# EX16.17.2

LAKESHORE PLANNING COUNCIL CORP.

June 27, 2016

Re: EX 16.17 - Waterfront Transit Network Vision - Phase 1

# SOUTH ETOBICOKE—MISSISSAUGA AREA LRT (SEMALRT) PROPOSAL

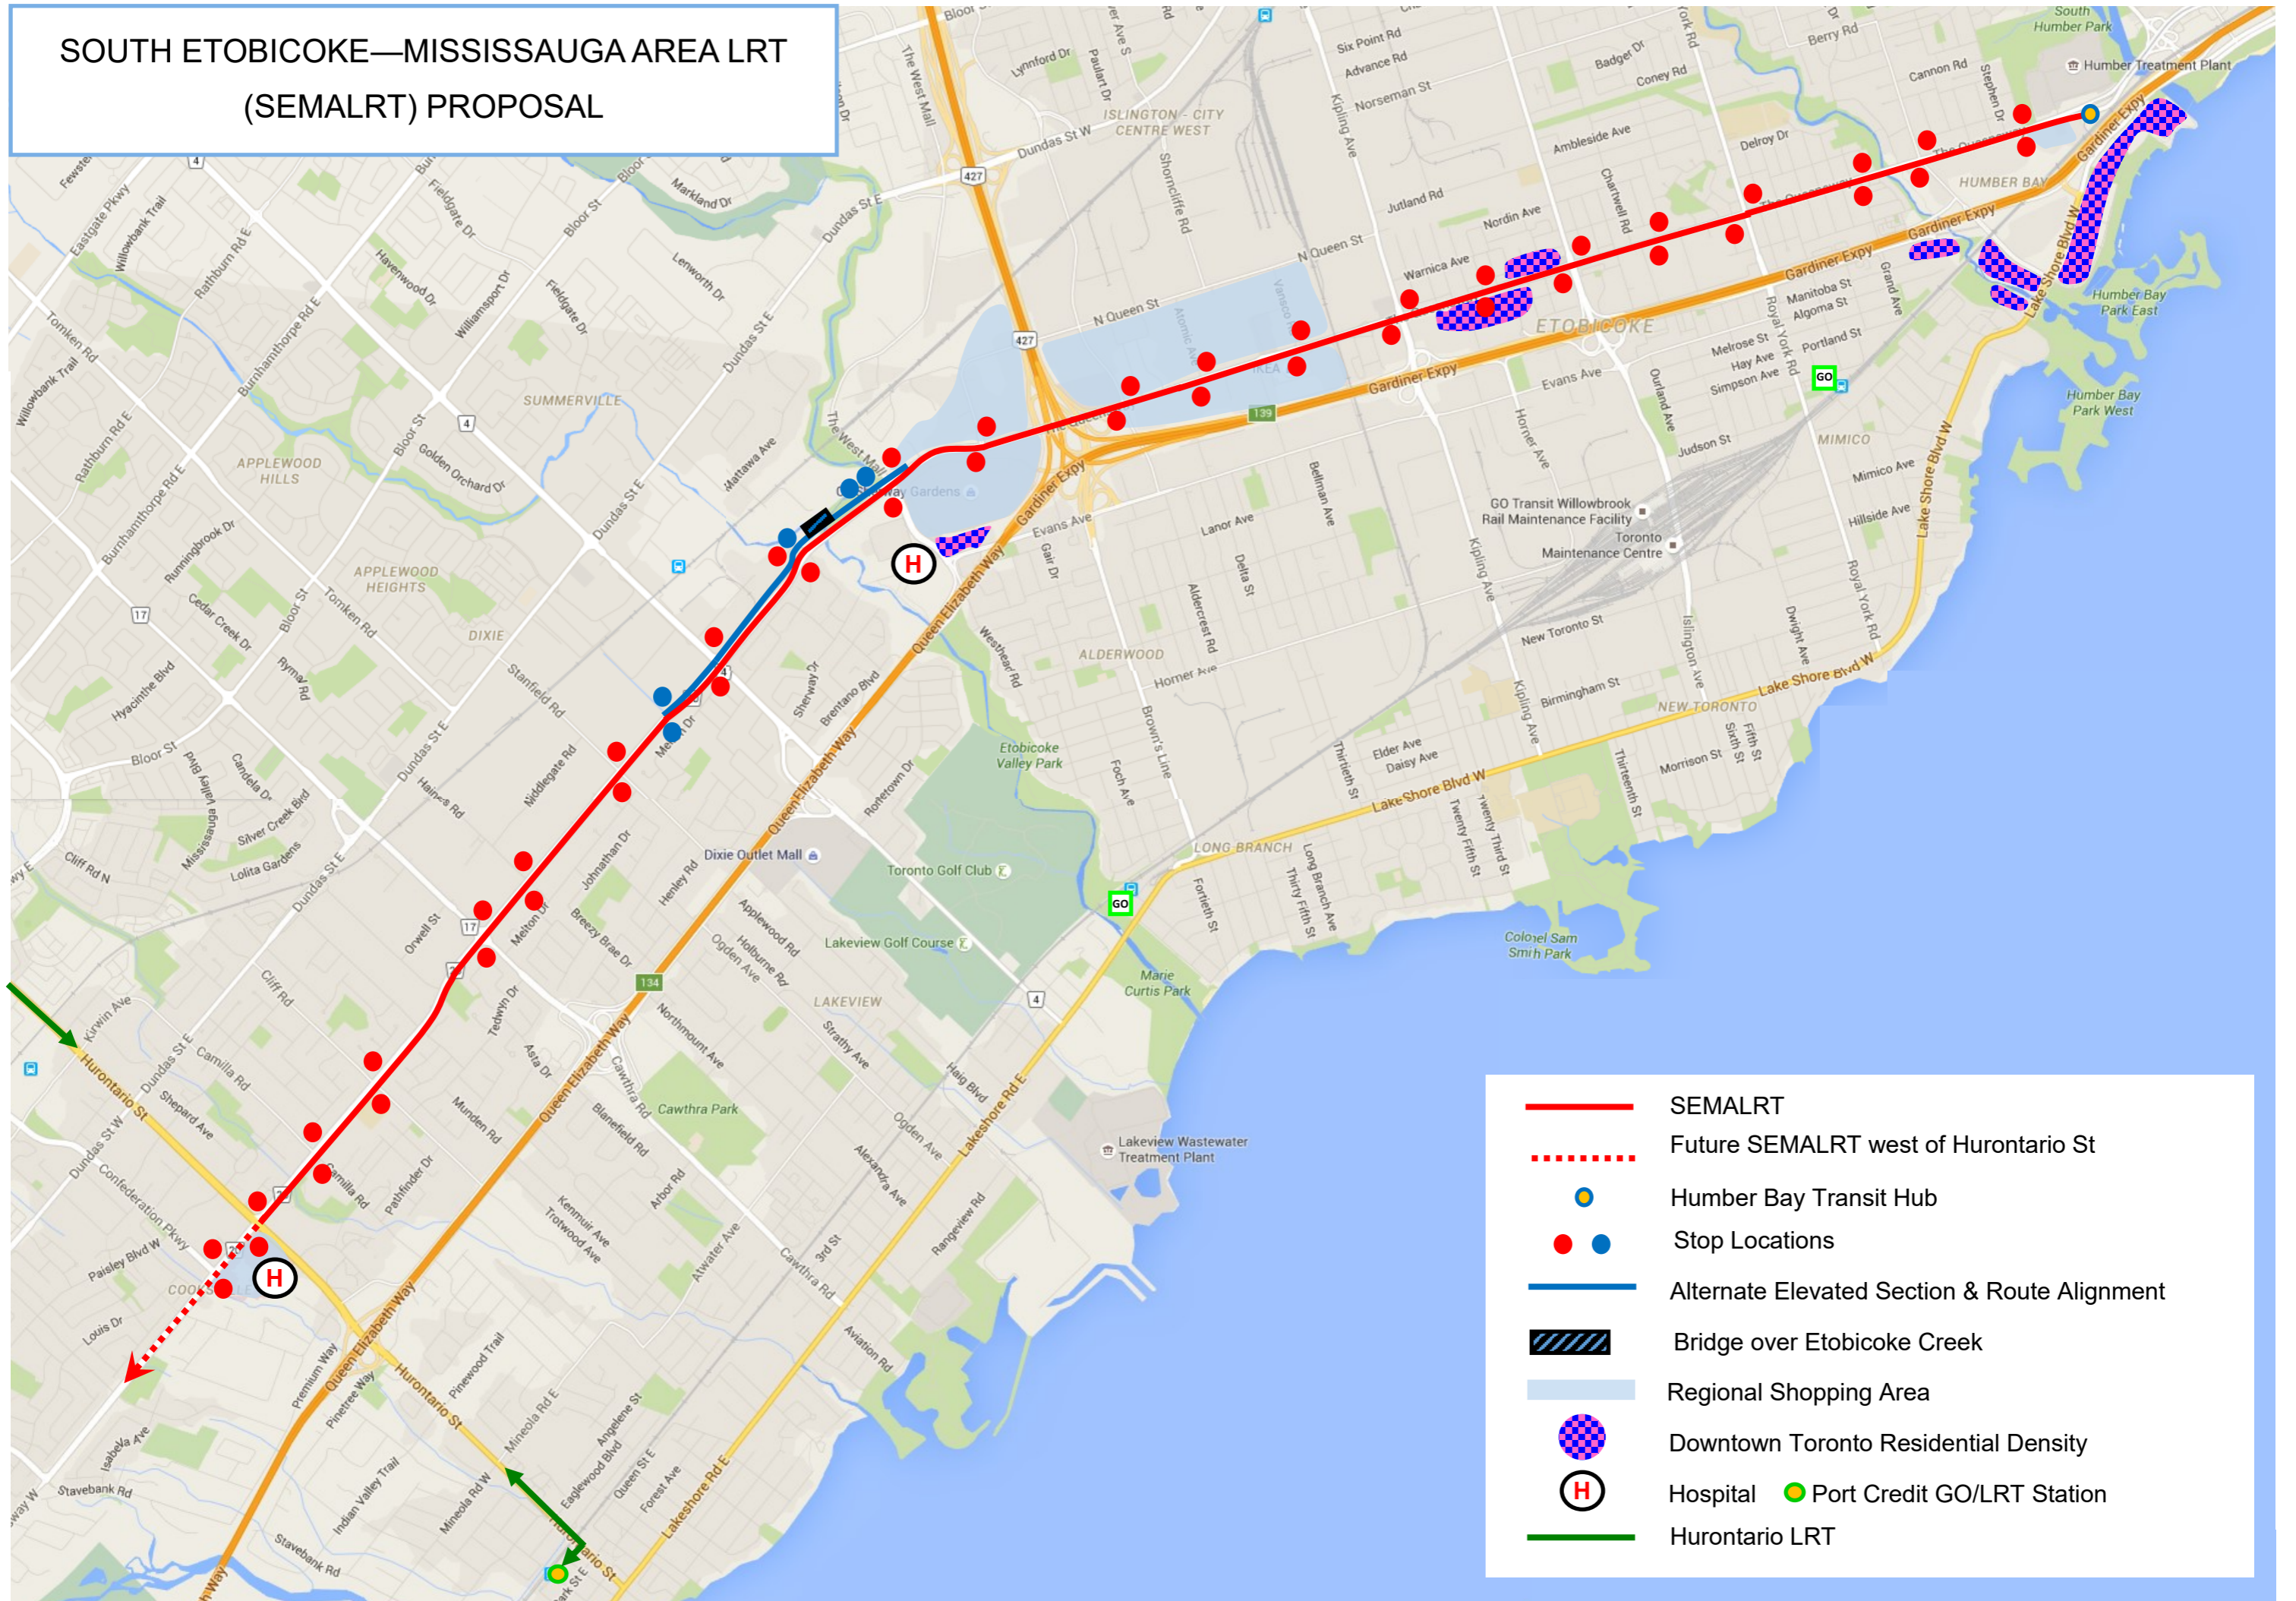
8. An **LRT along The Queensway** through southern Etobicoke and Mississauga will have a significantly greater ridership capture area than a waterfront LRT could ever possibly have.

9. The Queensway is typically wider than Hurontario St., where an LRT from Port Credit GO Station to Brampton is being built.
10. Note that no LRT can be built on Lakeshore Road through Port Credit for the same reasons as for The Lakeshore area.
